RESPONSES TO CURE DATA REQUESTS SET ONE

APPLICATION FOR CERTIFICATION (07-AFC-8)
Carrizo Energy Solar Farm
Carrizo Energy, LLC

Subject: Carrizo Energy Solar Farm (07-AFC-8)
Applicant's Responses to CURE Data Requests Set One
URS Project No. 27658060.01800

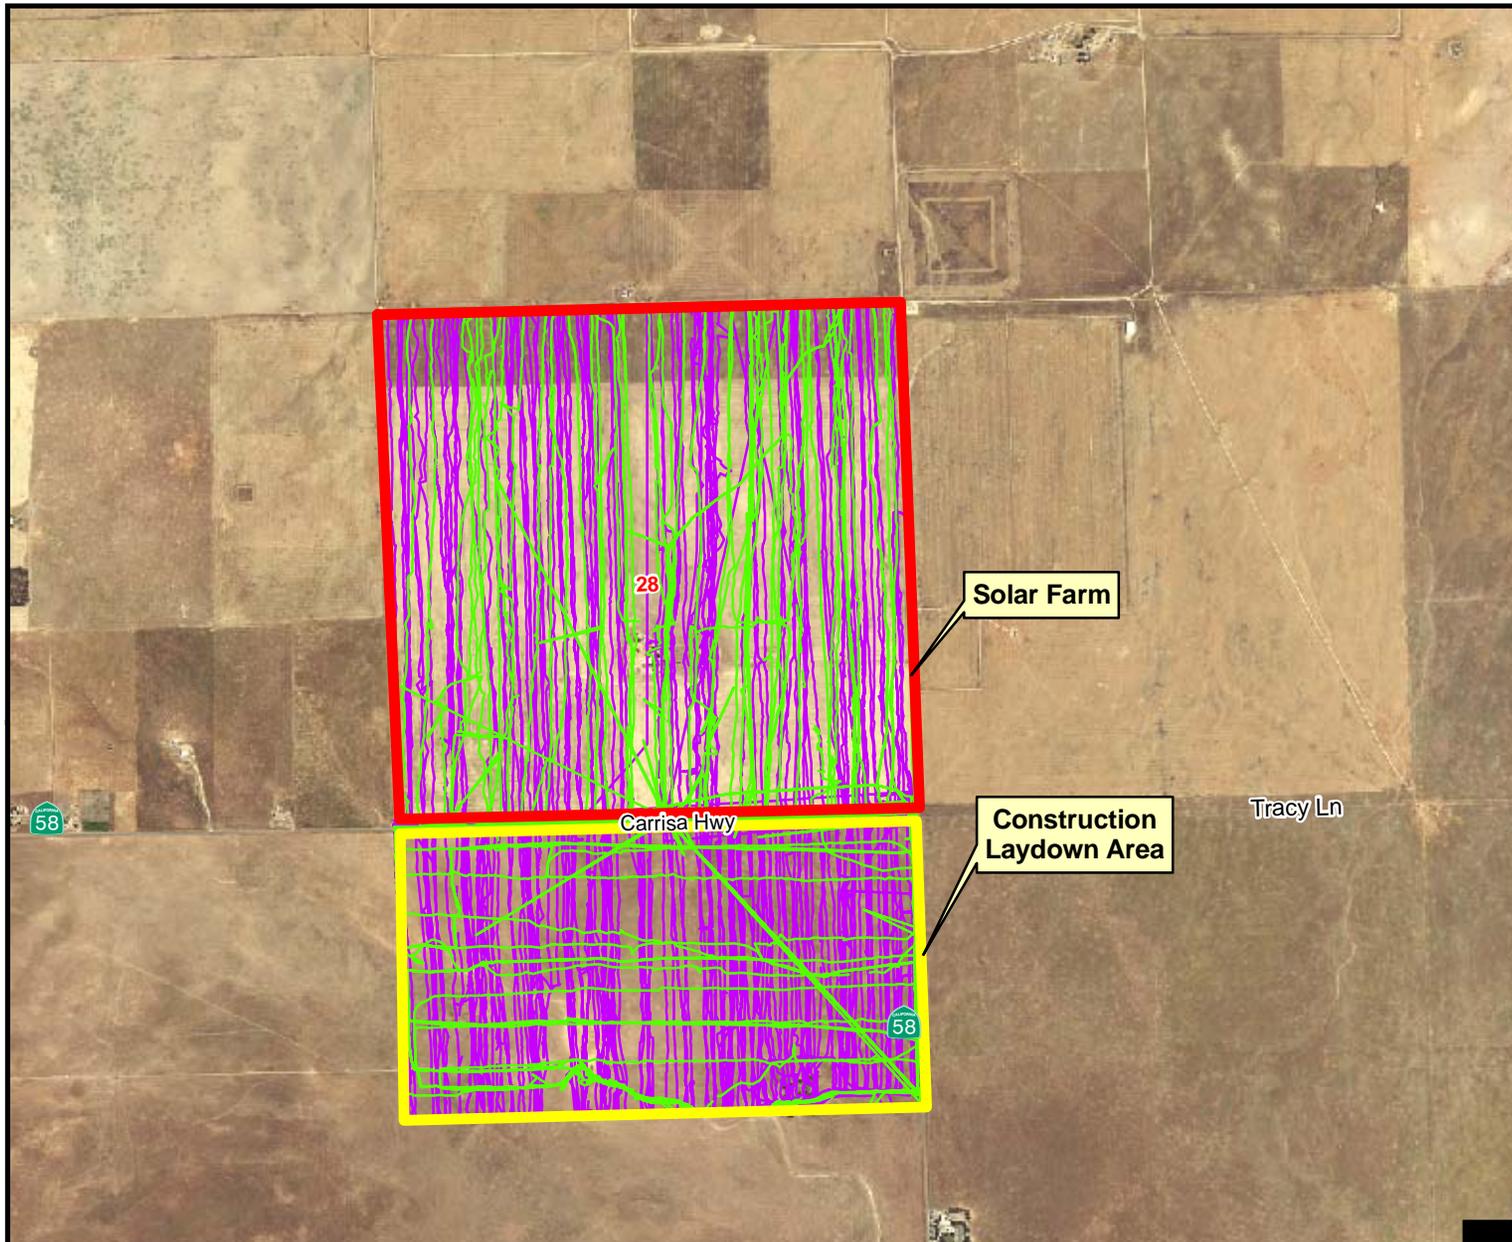
Data Request 40: Please provide a map of BNLL survey routes and associated plant communities.

Response: Please see the attached map (Figure 1) of survey transects. Survey data sheets have been provided in the Project AFC. Data sheets for the second year of surveys will be provided upon completion of the 2008 BNLL surveys, which is expected to be in August 2008. The BNLL surveys were conducted according to the CDFG protocol.
